Product Change Notification

Product Change #: PCN377

Posting Date: April 18, 2018

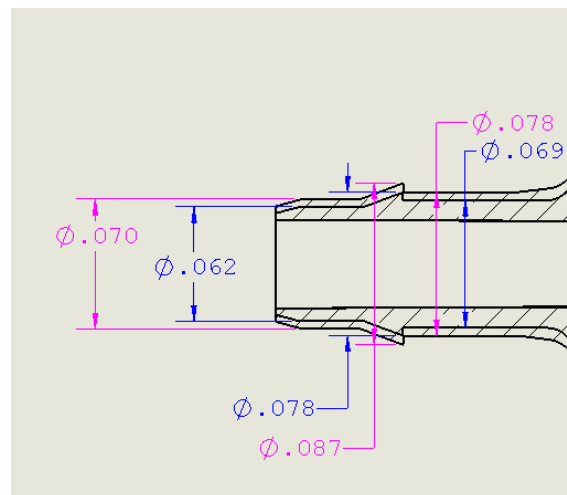
Description of Change: FTLL410 Female threaded locking Luers are undergoing a change to the exterior geometry of the barbs to improve manufacturing efficiencies and enhance part quality. This change does not impact the flow path of the part but it will minimally impact the exterior barb geometry which interfaces with the tubing. New part samples will be available starting June 1st.

Before

After
